▲ = Revised October 2005. This bulletin supercedes the previous bulletin 2004-05 July 2004.

Gen II Cool Fuel Pump Replaced by Pump / Cooler Kits

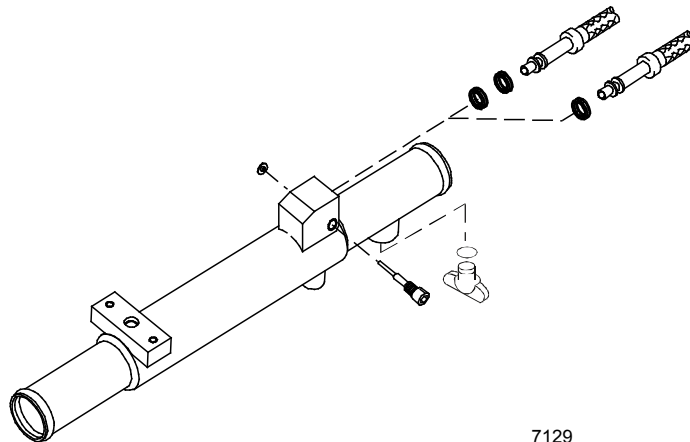
The fuel pump for the Gen II Cool Fuel System is no longer available as an individual component. The pump will now be available only as part of a Pump and Cooler Kit, which includes the fuel pump, fuel cooler, and hardware. Three kits will be available, and the applications for each kit are described below.

The various coolers are not interchangeable, therefore, be sure to order the correct kit for the model and serial number of the engine being repaired.

861156A03 - Fuel Pump / Cooler Kit Without Drain - has fuel cooler (865356), which is shorter, does not have a water drain port, and has a cross bolt to retain the fuel line to the fuel cooler outlet

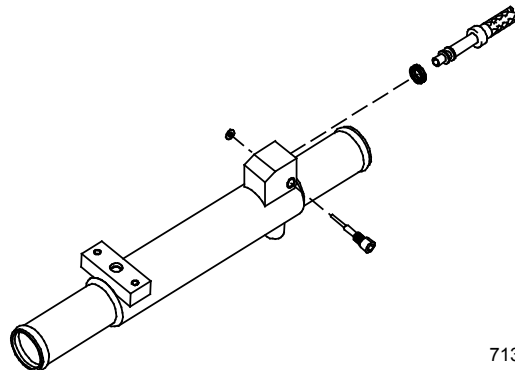
MCM 4.3 MPI (Alpha and Bravo)	0M300000 & up
MCM 5.0 MPI	0M300000 & up
MCM 350 MAG MPI	0M300000 & up
MCM MX6.2 MPI	0M300000 & up
MIE 350 MAG MPI	0M300000 & up
MIE MX6.2 MPI	0M300000 & up

861156A04 - Fuel Pump / Cooler Kit With Drain - has fuel cooler (807950), which has an integral water drain port and has a fuel line retaining bolt that is parallel to the fuel line to attach the fuel line to the fuel cooler outlet

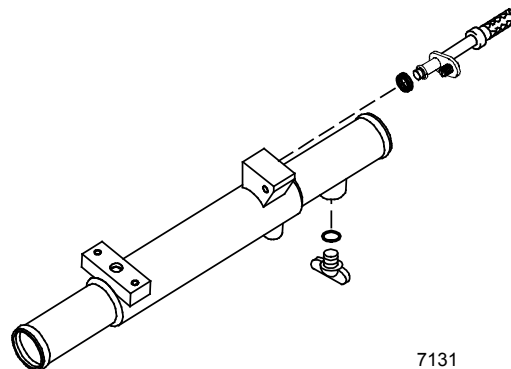
All MPI, EFI, and TBI models with Cool Fuel 0K999999 & lower (▲ Read the following Note.)

NOTE: ▲ Numerous engines with serial number 0K999999 and lower were affected by Service Bulletin 1997-20. Repairs done under this bulletin resulted in a change in the fuel lines and a change in the cooler to the cross-bolt style fuel line attachment. To determine the correct fuel pump and cooler kit on these engines it will be necessary to determine the method of retaining the fuel line on the cooler. If the cooler is original and the fuel line is retained by a bolt on a fuel line flange, use kit 861156A04. If the fuel cooler was replaced and the fuel line is retained by a fuel line retainer screw (cross bolt style), use kit 861156A02.
